Notice of Intent

Sundry ID: 2754851

Type of Action: APD Change

Procedure Description: Mewbourne Oil Company request a variance to perform break testing and offline cementing on the following wells: Querecho 23/26 Fed Com 523H Querecho 23/26 Fed Com 616H Night Watch 2/1 Fed Com 511H Night Watch 2/1 Fed Com 513H Gemini 36/35 Fed Com 513H Gemini 36/35 Fed Com 516H Corona 25/26 Fed Com 525H Corona 25/26 Fed Com 528H Pavo Macho 31/33 Fed Com 616H Pavo Macho 31/33 Fed Com 618H

Figure 1. Cactus 13 3/8" 5M offline cementing tool. Pressure rating limited by the lesser of 5M tool rating or the 13 3/8" pup joint and casing.

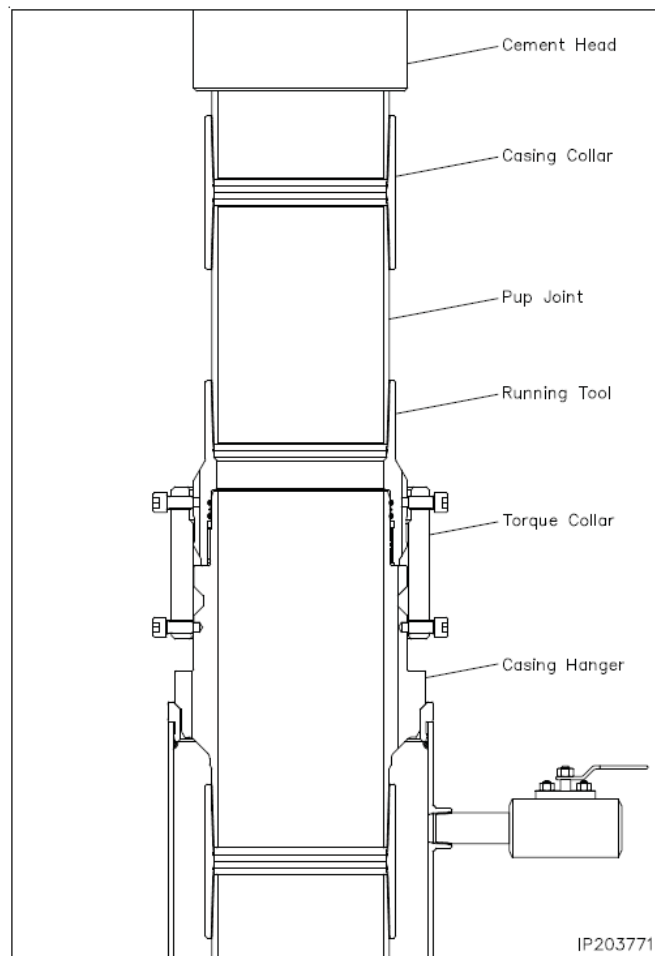
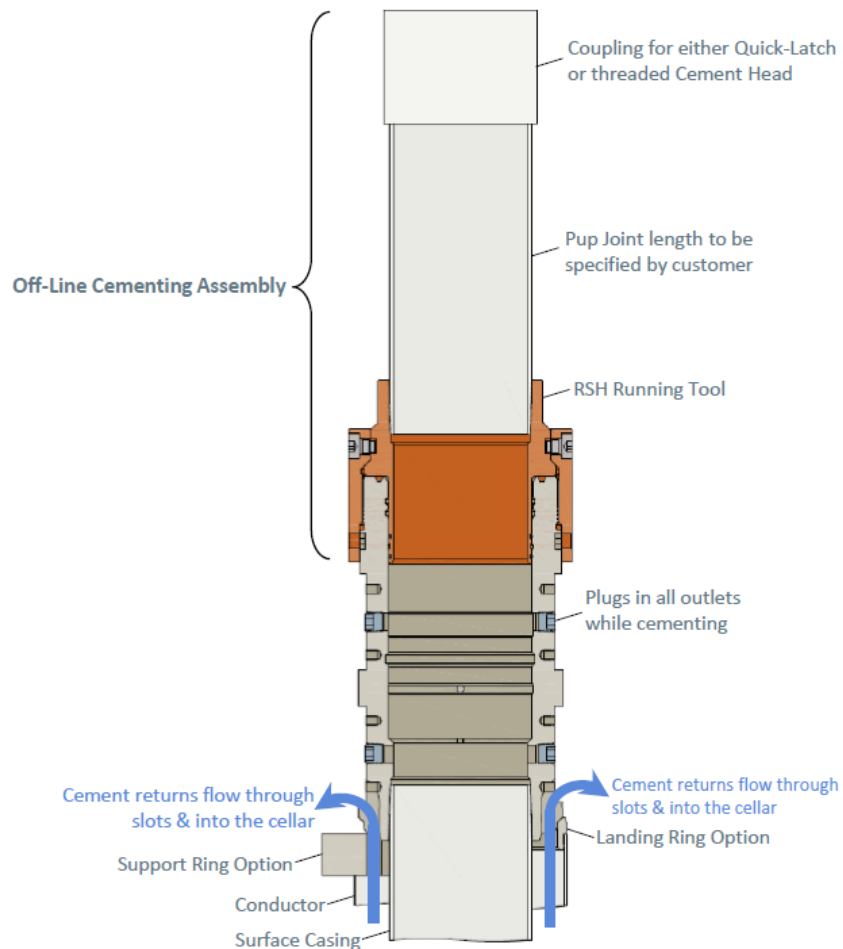
9. Make up offline cement tool with forklift per wellhead manufacturer (Fig. 1 & 2).
10. Make up cement head on top of offline cement tool with forklift.

Offline cementing variance is approved for surface and intermediate casings only. Contact the BLM prior to the commencement of any offline cementing procedure.

Figure 3. Cactus 9 5/8" 5M offline cementing tool. Pressure rating limited by the lesser of 5M tool rating or the 9 5/8" pup joint and casing.

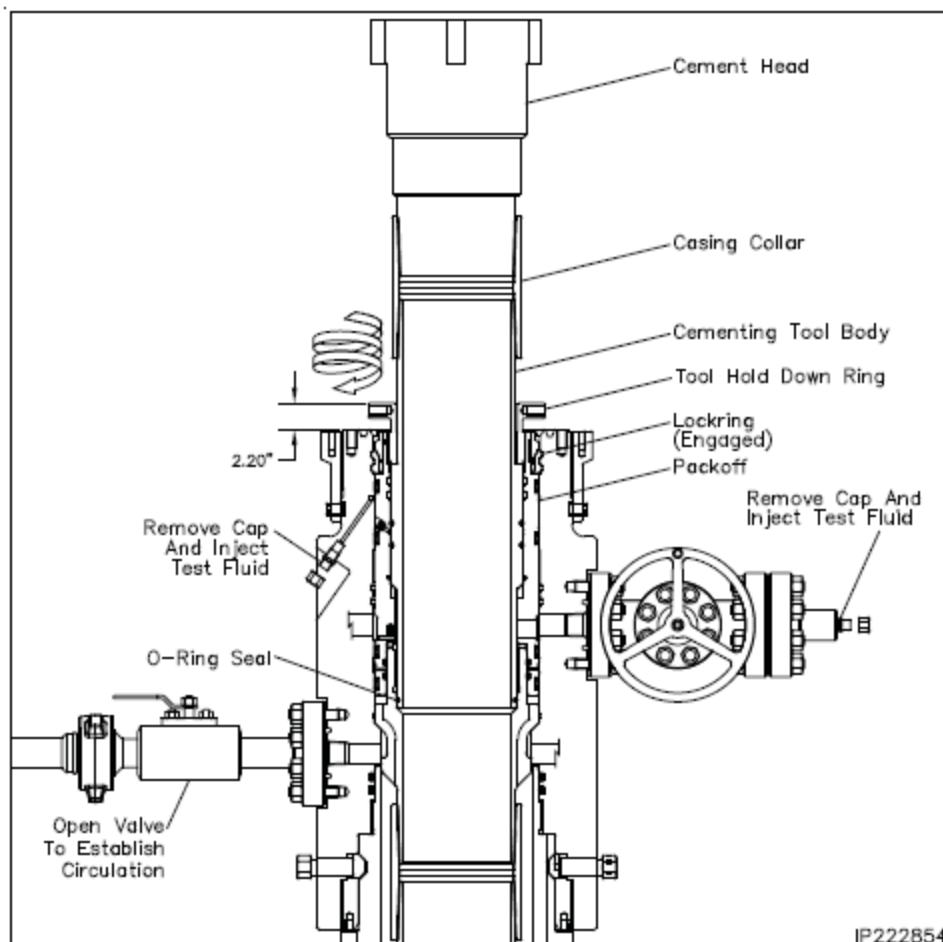
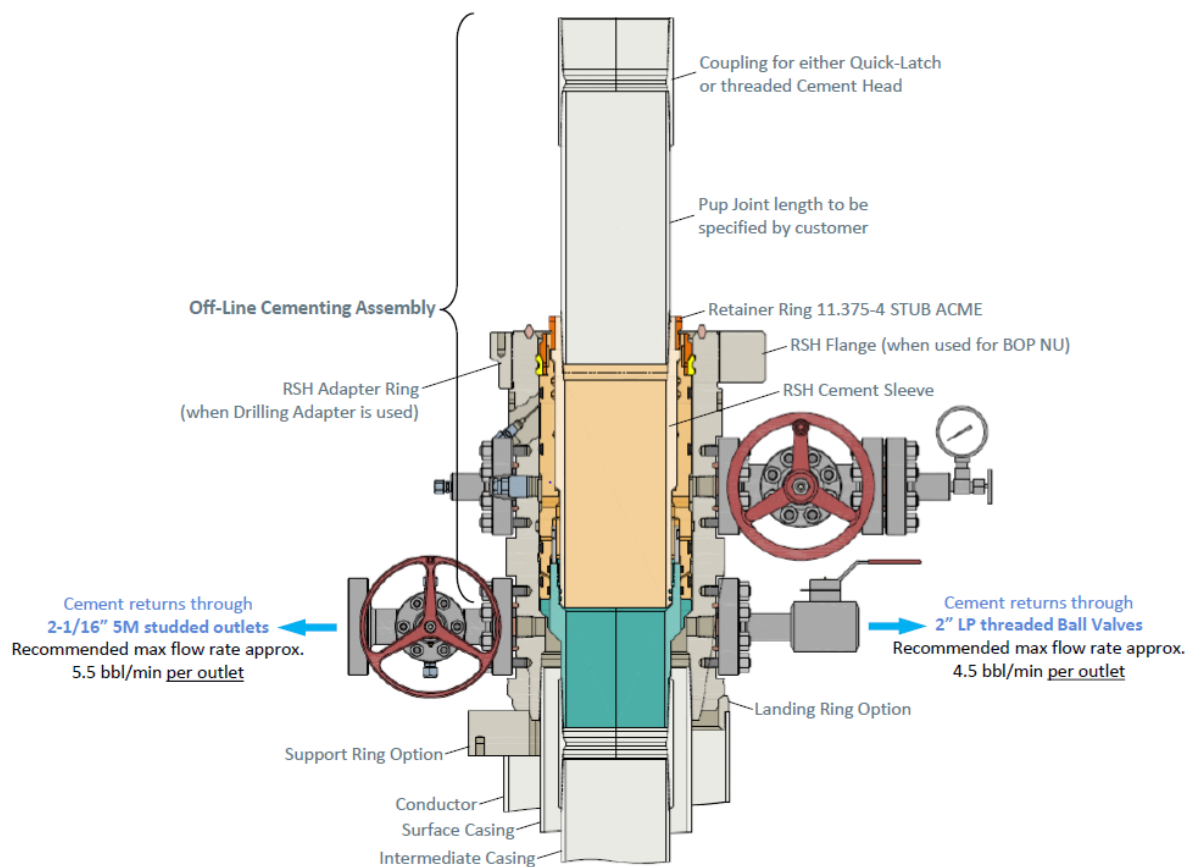
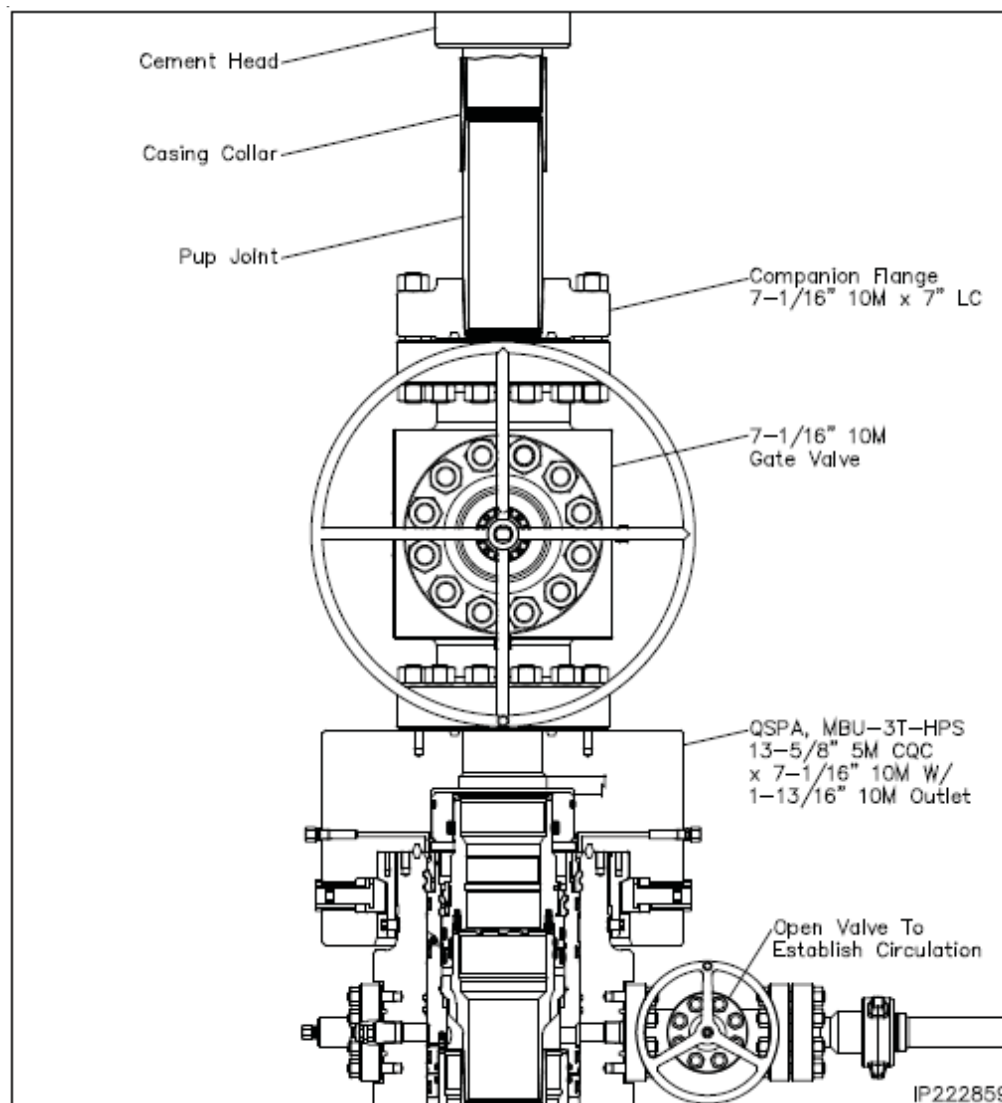
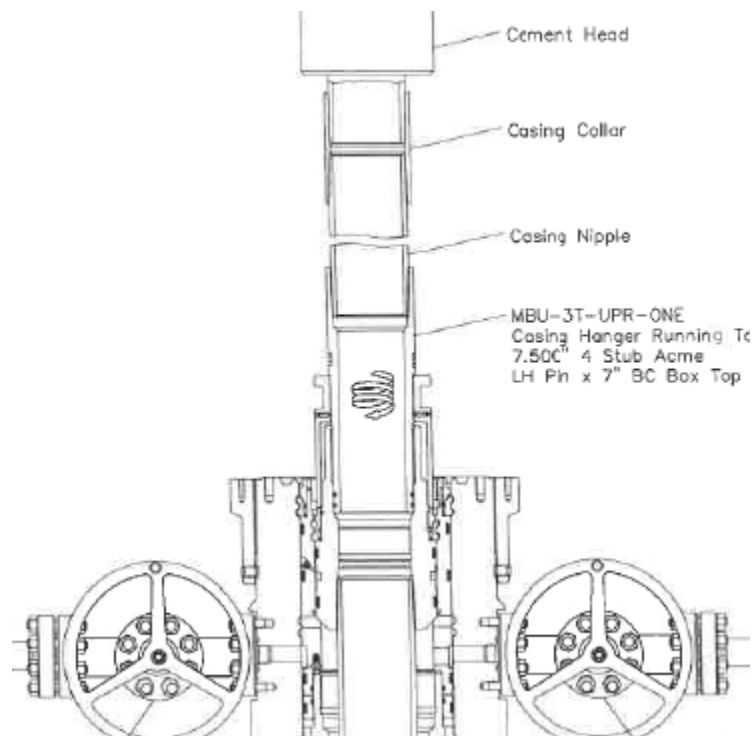
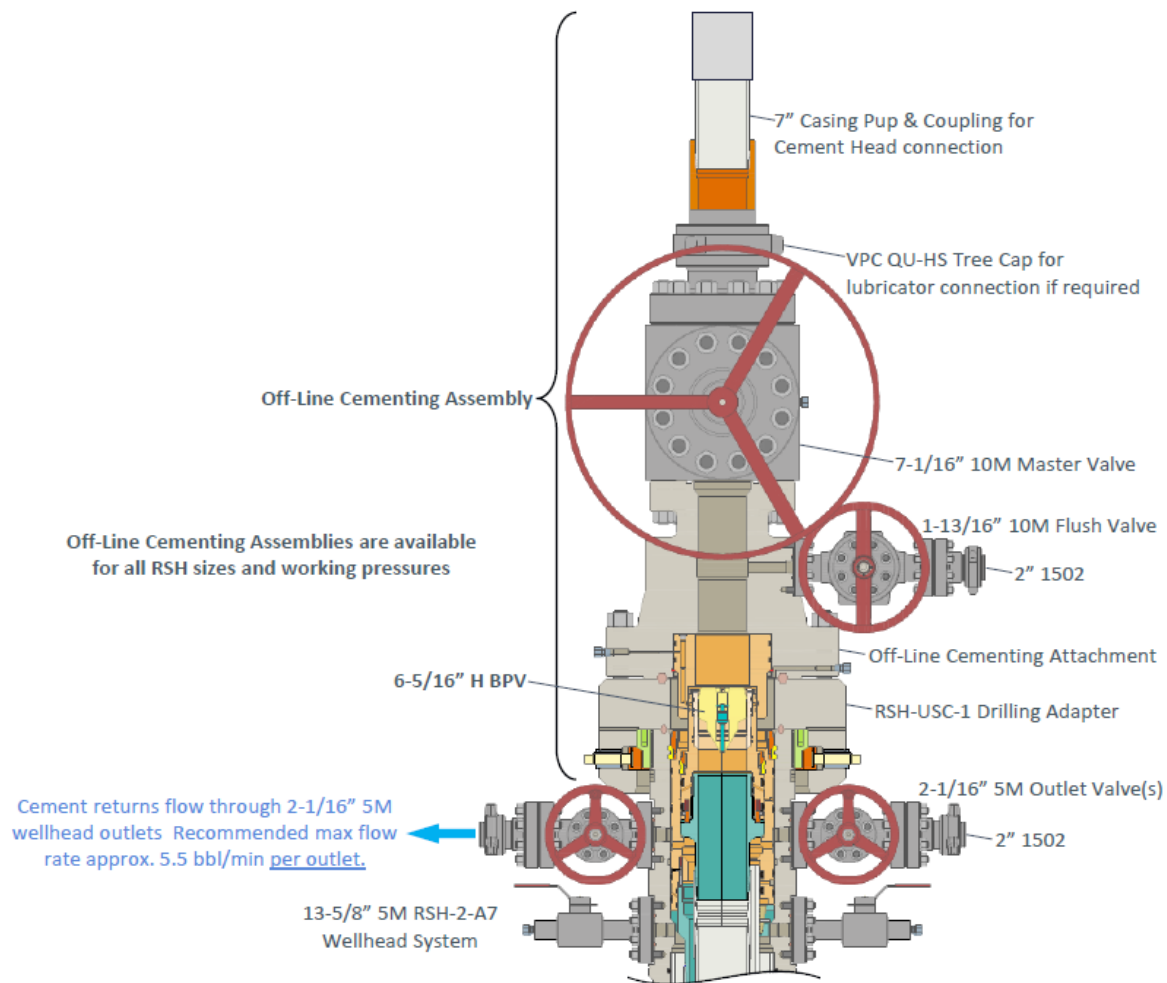
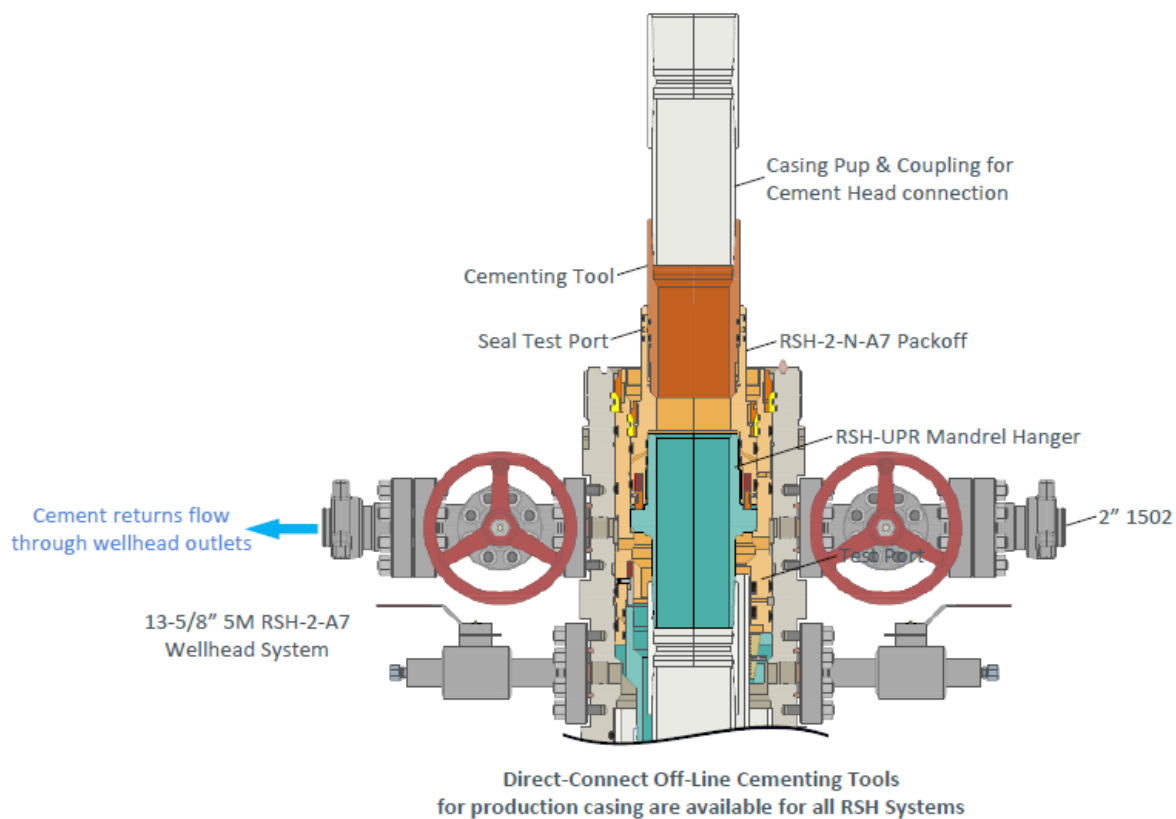
10. Make up offline cement tool using forklift per wellhead manufacturer (Fig. 3 - 8).
11. Make up cement head on top of offline cement tool.
12. Commence cement operations.

Figure 1. BOP diagram

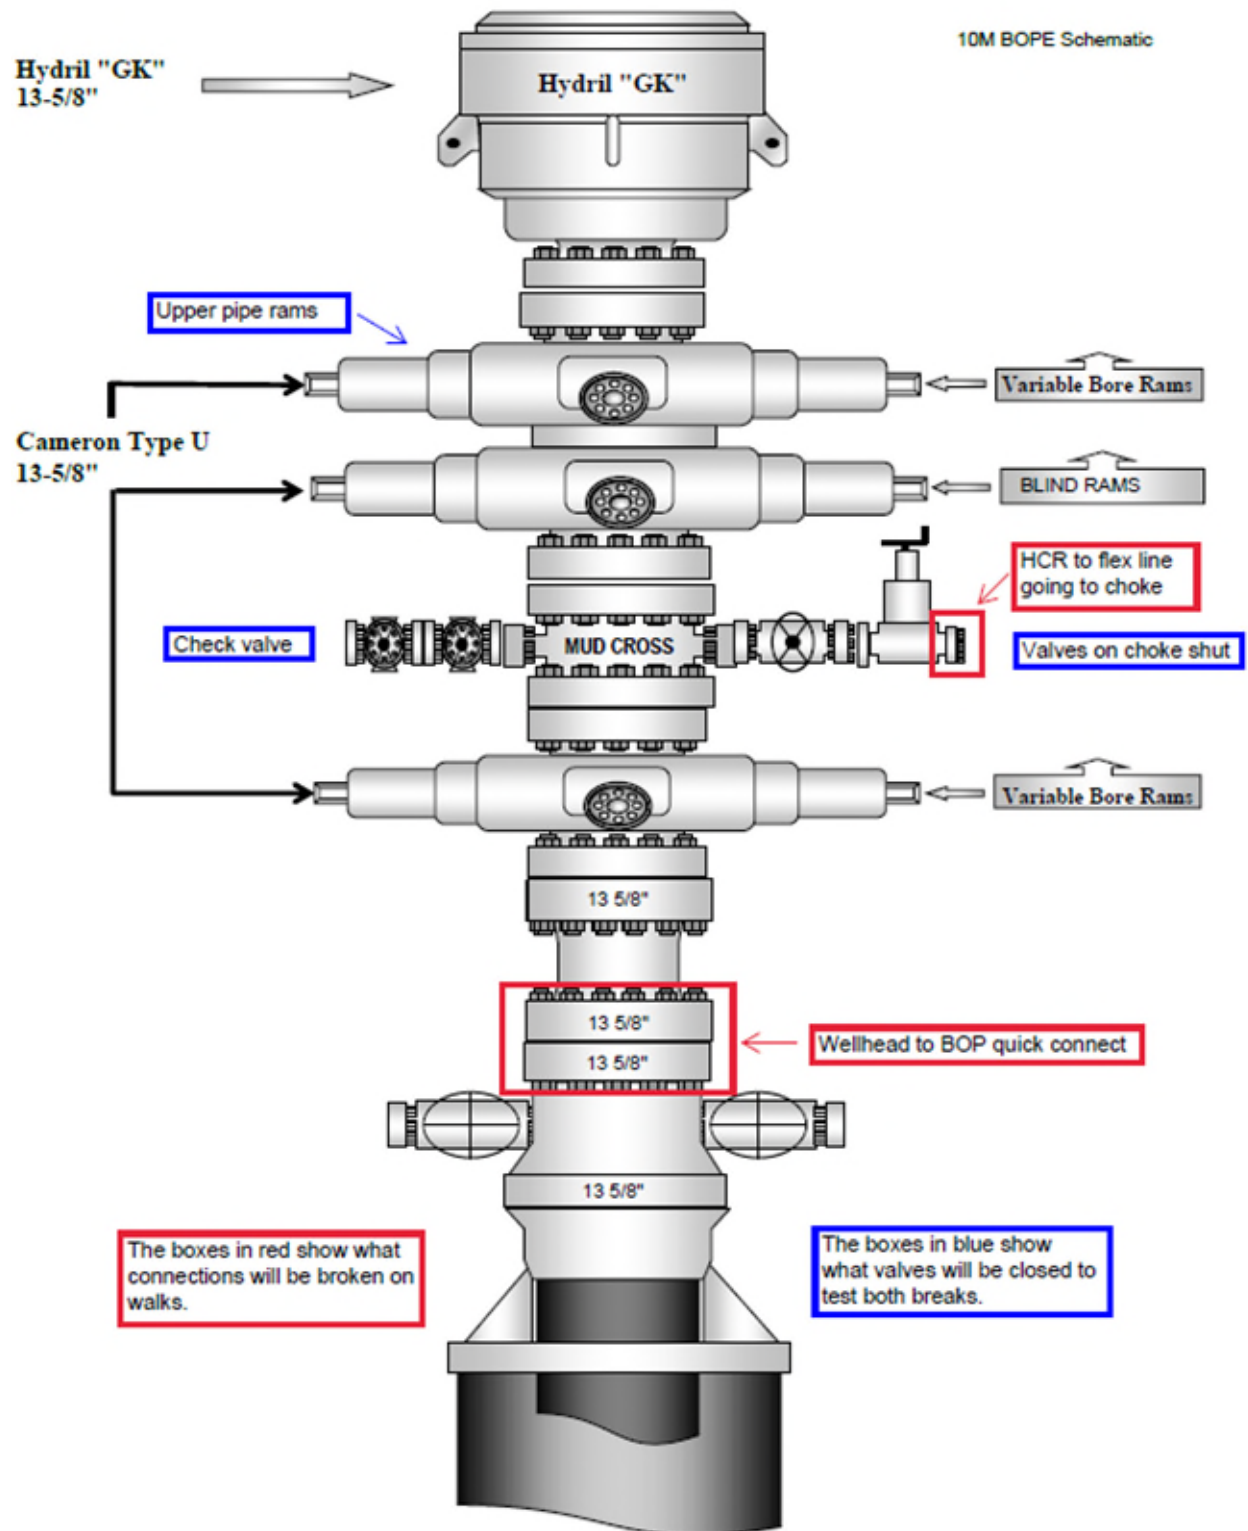
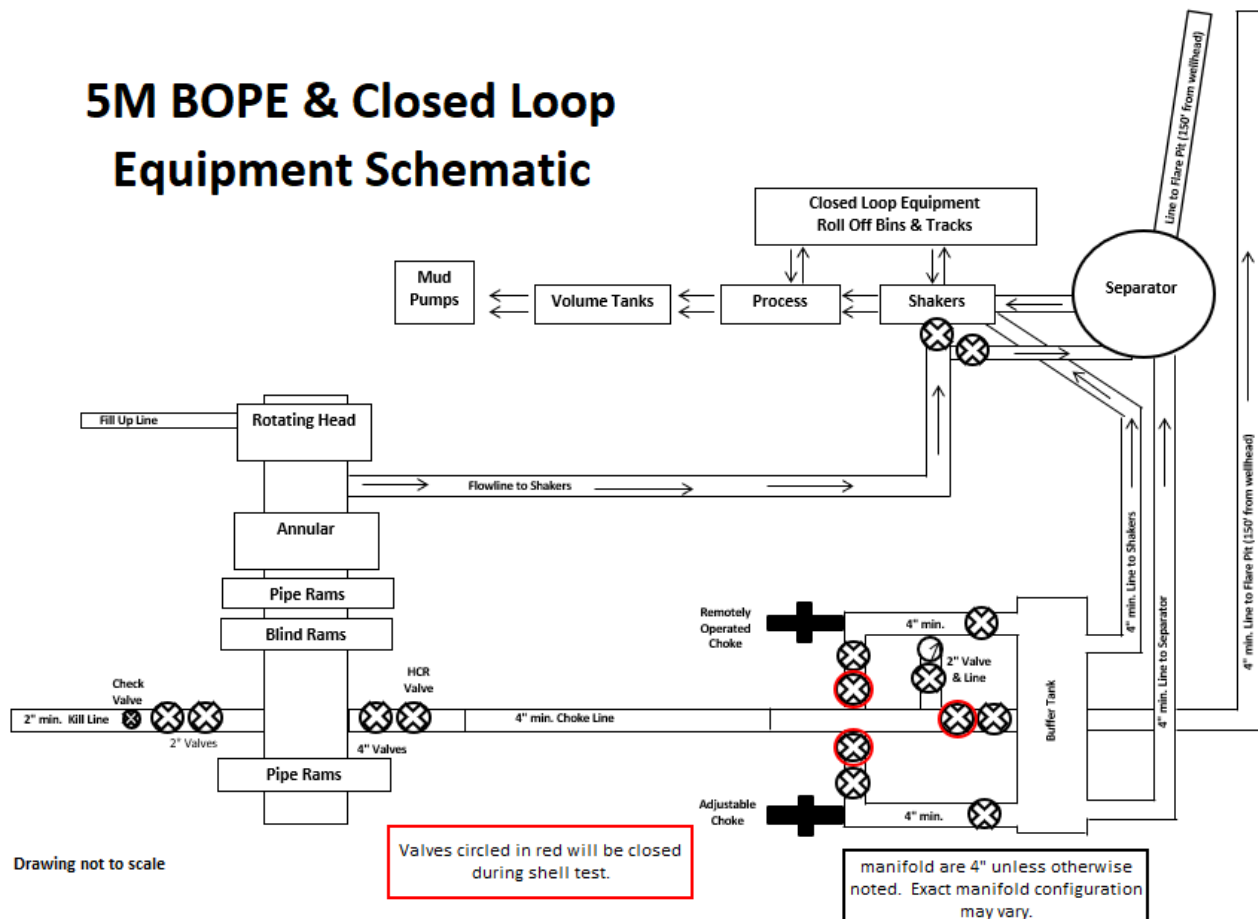
2. After the well section is secured and the well is confirmed to be static, the BOP will be disconnected from the wellhead and walked with the rig to another well on the pad. Two breaks on the BOPE will be made (Fig. 1).

9. A test will then be conducted against the upper pipe rams and choke, testing both breaks (Fig. 1 & 2).
10. The test will be held at 250 psi low and to the high value submitted in the APD, not to exceed 5000 psi.

- BOPE Break Testing is ONLY permitted for 5M BOPE or less. **(Annular preventer must be tested to a minimum of 70% of BOPE working pressure and shall be higher than the MASP)**

- BOPE Break Testing is NOT permitted to drilling the production hole section.
- Variance only pertains to the intermediate hole-sections and no deeper than the Bone Springs formation.
